UNITED STATES
NUCLEAR REGULATORY COMMISSION
WASHINGTON, D. C. 20555

APPLICANT: Public Service Electric & Gas Company (PSE&G)
FACILITY: Hope Creek Generating Station
SUBJECT: SUMMARY OF STRUCTURAL AND GEOTECHNICAL ENGINEERING
BRANCH (SGEB) MEETING

On August 1, 1984, a meeting was held in the Bethesda, Maryland offices of the NRC to discuss the remaining SGEB-Structural audit open items identified in the Draft SER. A list of meeting attendees is included as Enclosure 1 to this meeting summary.

FIGURE A-13-17
 RESPONSE SPECTRA COMPARISON,
 AUXILIARY BUILDING AT ELEV. 54' - 0".

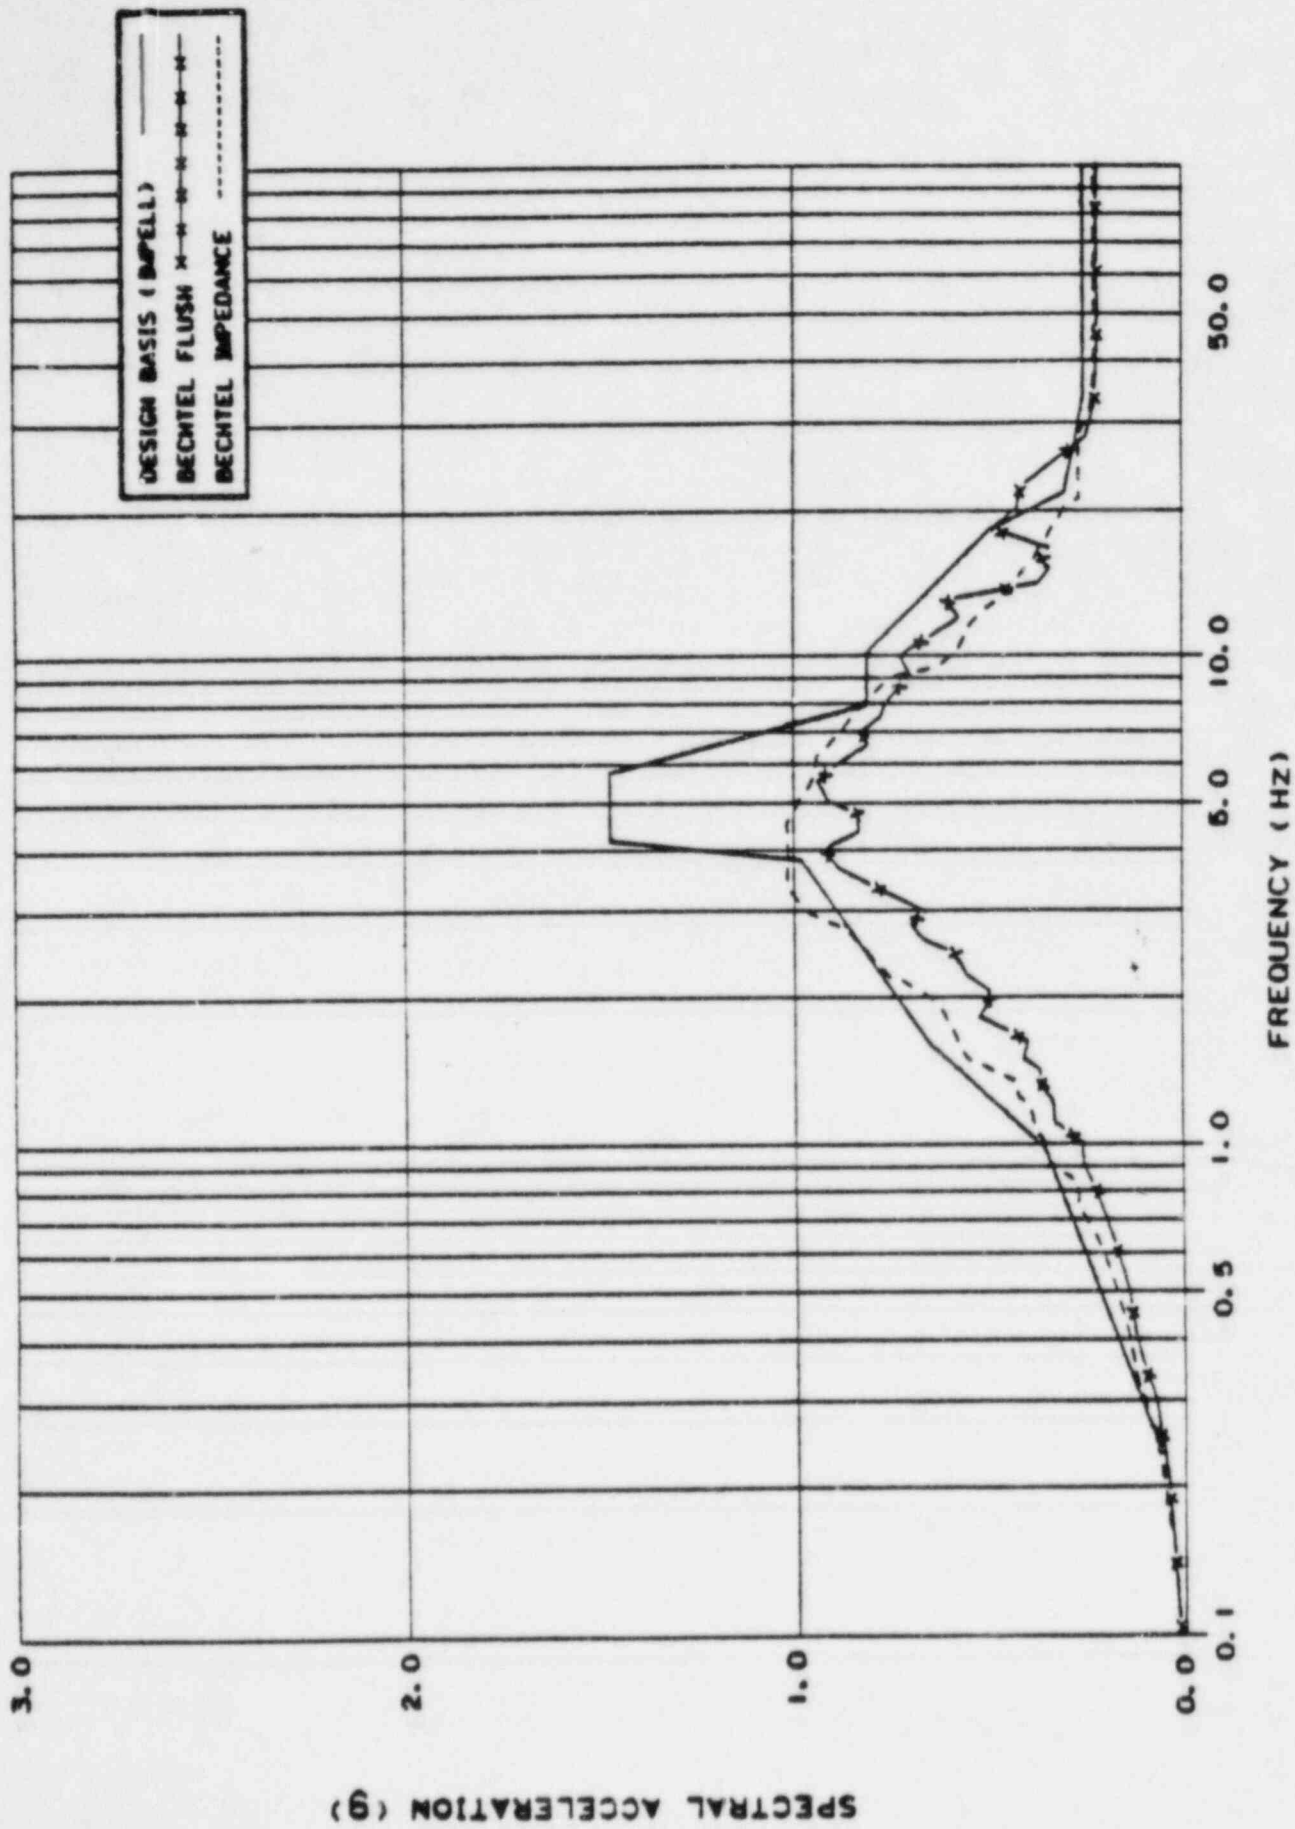
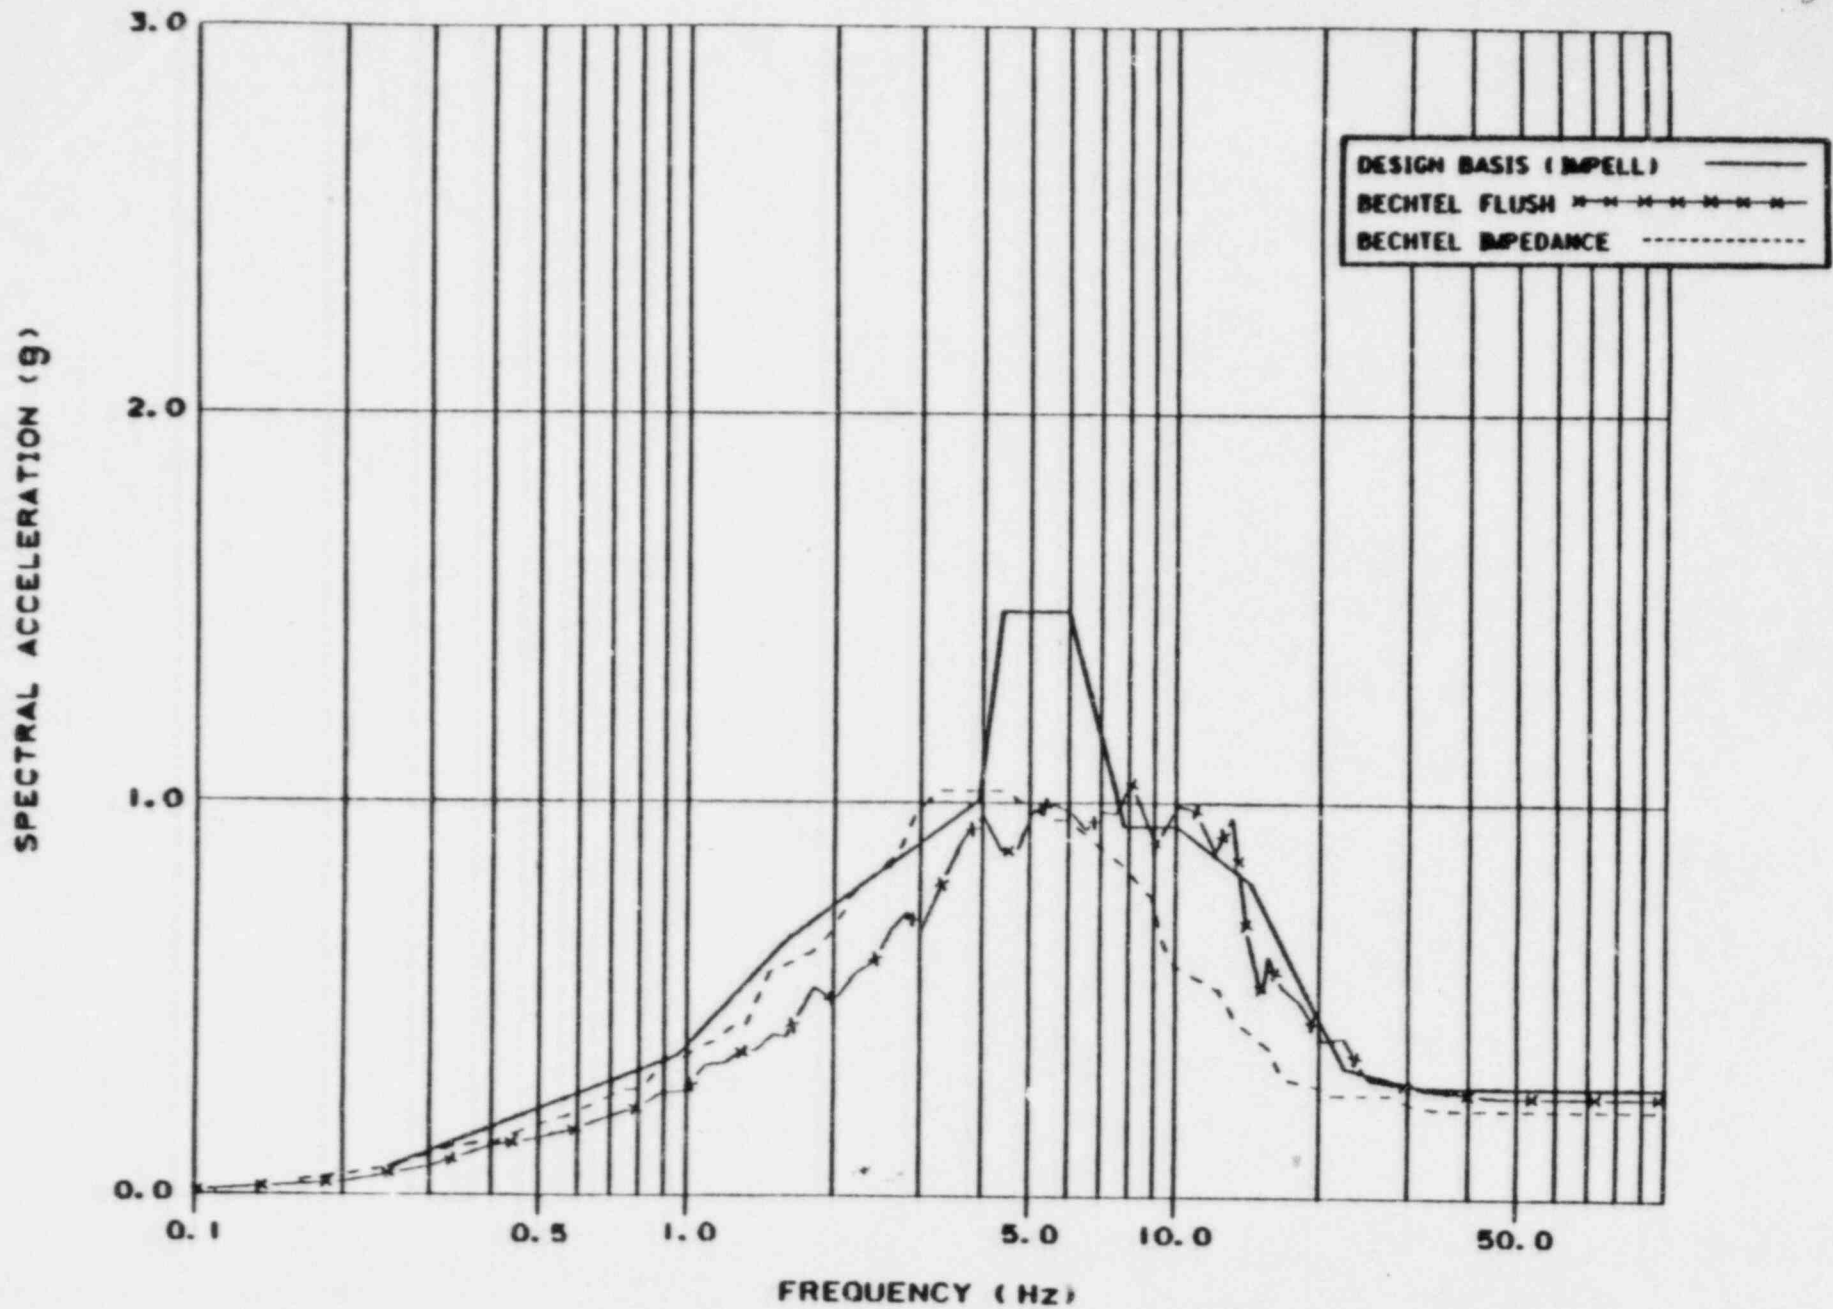
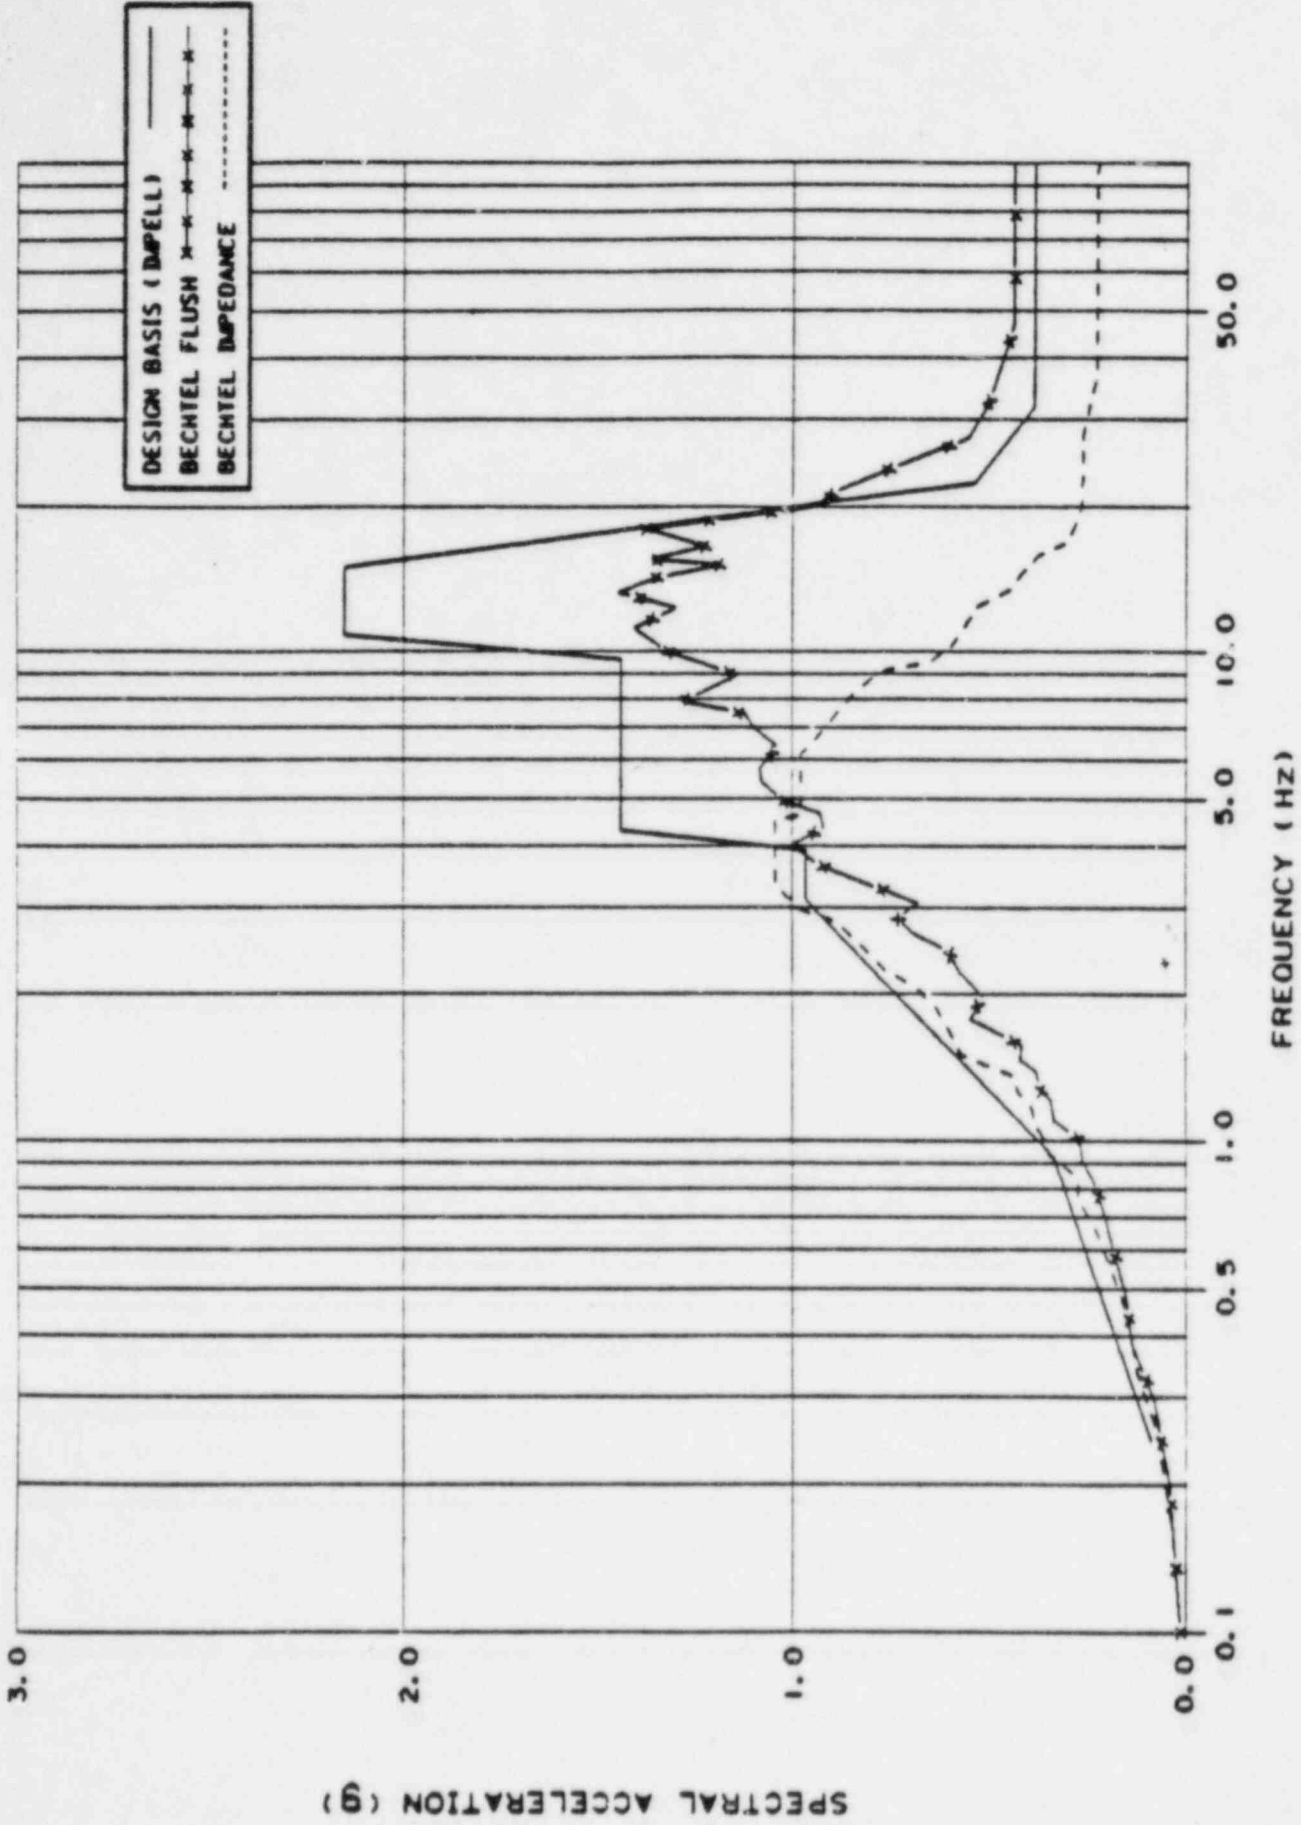
Question: Provide comparison of Bechtel Independent Verification Results with the Design Basis Results.

Figures A-13-2 to A-13-37 show the comparison of the response spectra (2% damping) obtained from the above three seismic soil-structure interaction analyses. Discussions of these comparisons are as follows:

Bechtel's independent soil-structure interaction analyses are performed using the computer code FLUSH. The results of independent finite element analyses are in reasonable agreement with those of the design basis analyses. As can be seen from Figures A-13-2 through A-13-37, the horizontal response spectra obtained from the independent finite element analyses are generally enveloped by those obtained from the design basis analyses except for the frequency range lower than 2 Hz. The vertical response spectra showed some exceedances at the frequency range of 18 Hz. These exceedances are listed in Table A-13-1.

The peak spectral accelerations obtained from the impedance approach analyses are generally lower than those obtained from the design basis analyses. However, these response spectra are not completely enveloped by those obtained from the design basis analysis, especially in the frequency range between 1.0 and 3.5 Hz. Also, there are some local exceedances in the higher frequency range, as shown in Figures A-13-2 through A-13-37.
